HISTORIC AND DESIGN REVIEW COMMISSION

HDRC CASE NO: 2022-505
ADDRESS: 515 CLUB DR
LEGAL DESCRIPTION: NCB 7070 (R MATAMOROS SUB), BLOCK 9 LOT 25
ZONING: RM-4, H
CITY COUNCIL DIST.: 7
DISTRICT: Monticello Park Historic District
APPLICANT: Gilbert Garza/Garza Design-Build LLC
OWNER: Celeste Leija
TYPE OF WORK: New construction of a 1-story, single-family residence
APPLICATION RECEIVED: September 16, 2022
60-DAY REVIEW: Not applicable due to City Council Emergency Orders
CASE MANAGER: Rachel Rettaliata

The applicant is requesting conceptual approval to construct an approximately 2,400-square-foot 1-story, single-family residential structure.

PROPOSED: 10' 0" WIDE CONC. DRIVEWAY PLAN.
SCALE: 1/8" = 1' 0".

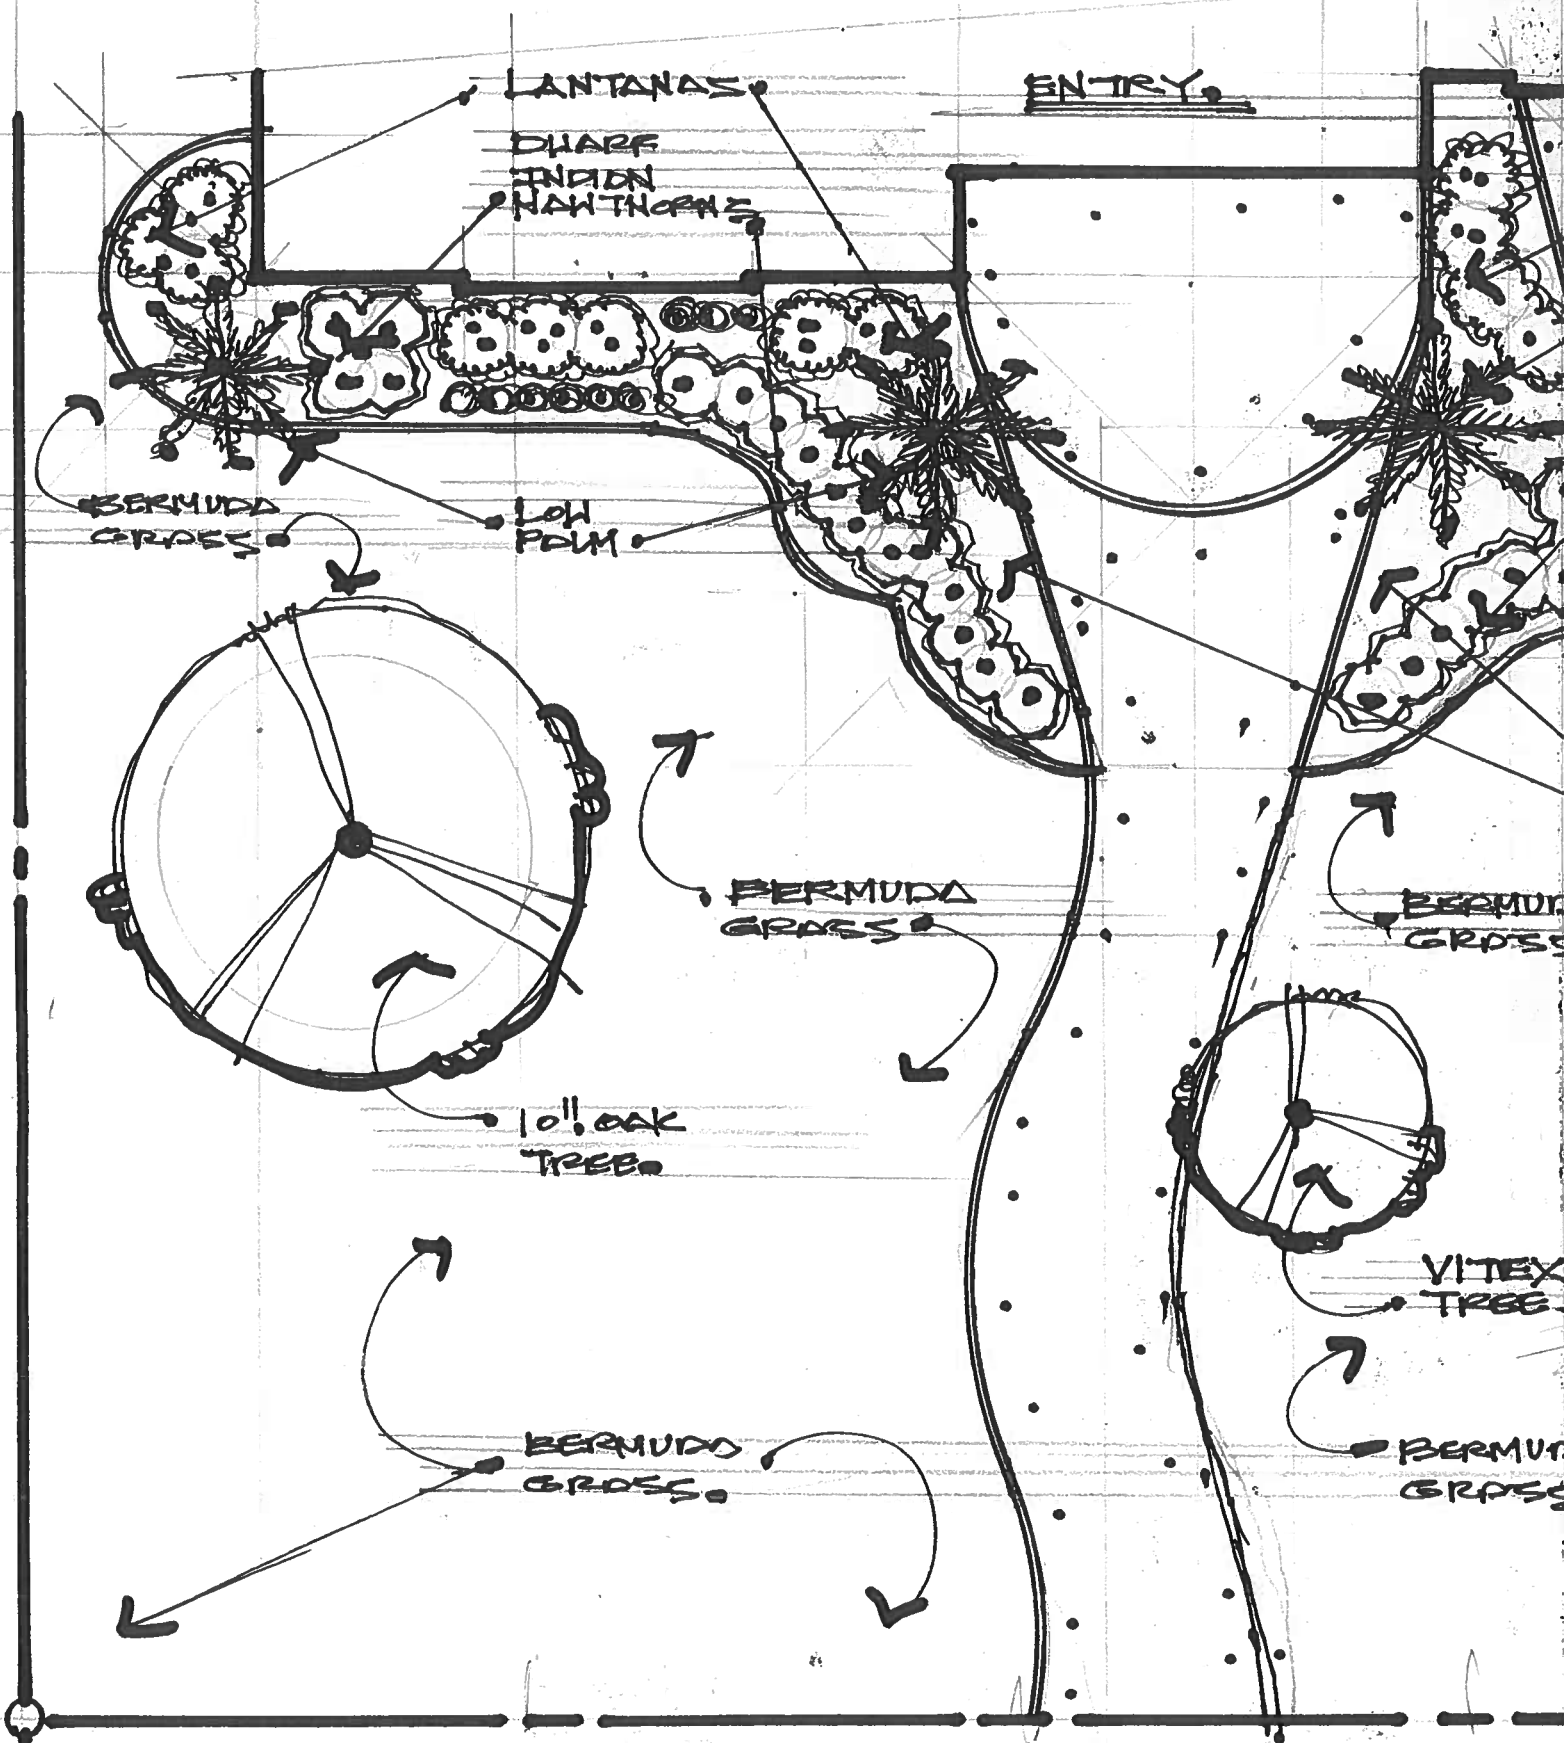
- x. That the applicant submits final dimensions for the proposed concrete driveway showing that the driveway will not exceed 10 feet in width to staff for review prior to returning to the HDRC for final approval based on finding m. ***This stipulation has been met.***

FRONT ELEVATION FOR MR. MRS. LEIJA

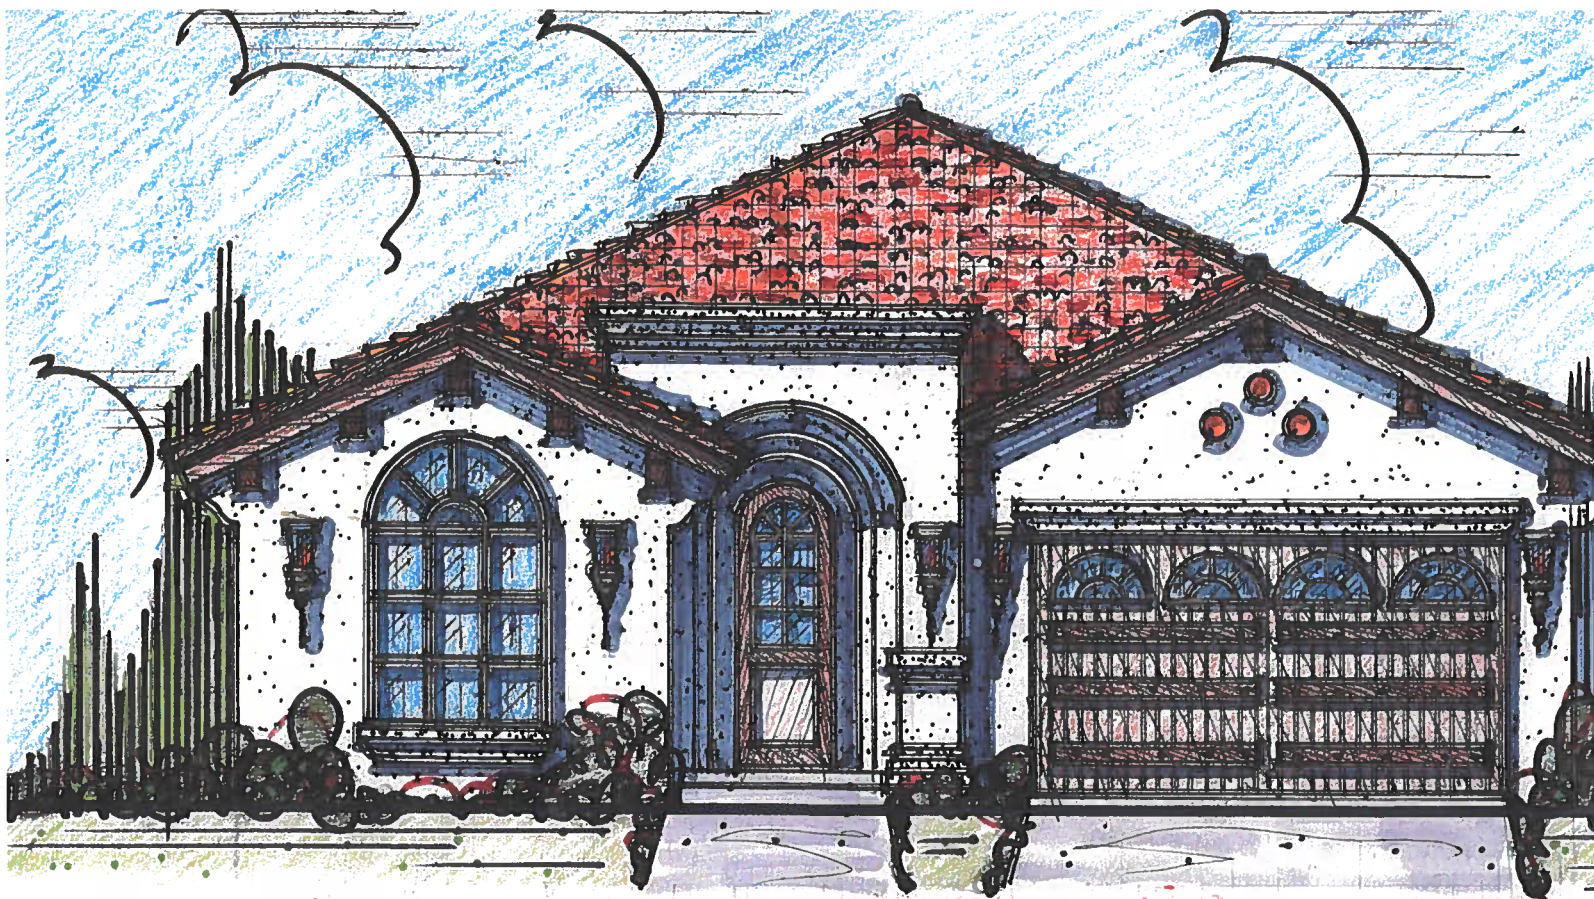
BM: The only concern the neighborhood still has, is the profile of the gable roof in the front.

LG: I think this neighborhood has a lot of different styles of homes and I don't think the gable is out of place or oversized or out of scale.
